Notice of Exhibition of application for 50-52 Phillip Street New Hotel Stage 1 Concept DA (SSD – 10464)

PRE-LODGE MENT ADVICE - 50 - 52 Phillip St - Chief Secretary's Building (SSD 10464)

Approvals Committee Sub Committee Design Discussion – Chief Secretary’s Building (50 – 52 Phillip Street, Sydney)

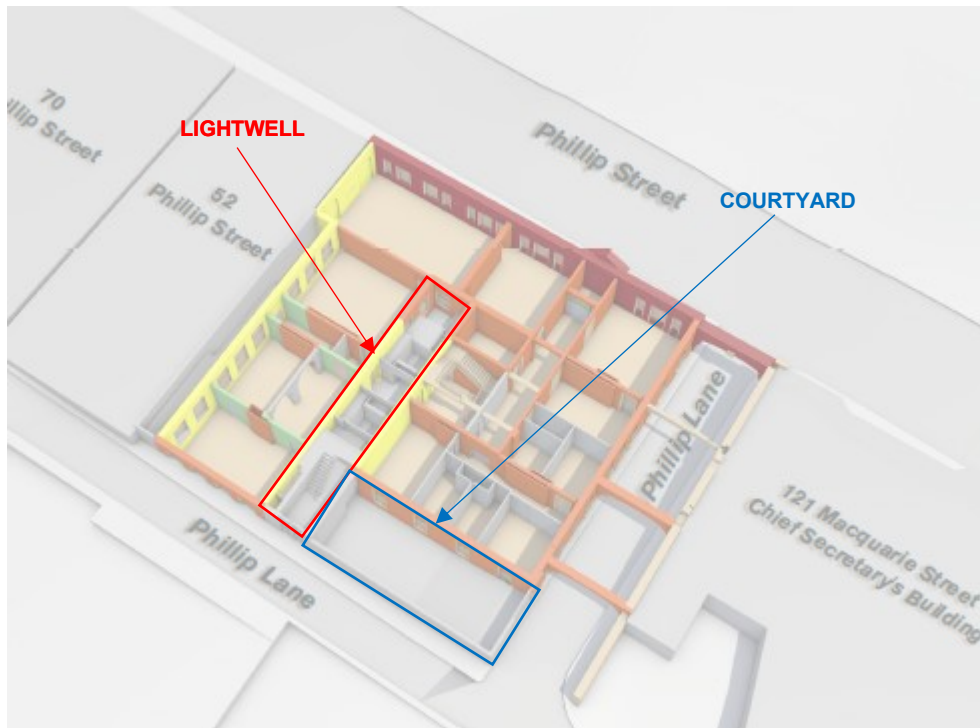
1. **Clarification of terms** “lightwell” and “courtyard” from the previous letter issued by HNSW to the applicant - “lightwell” refers to the central space contained between the built elements of the Former Public Works Building and “courtyard” refers to exterior western segment aligned along Philip Street (Figure 1).
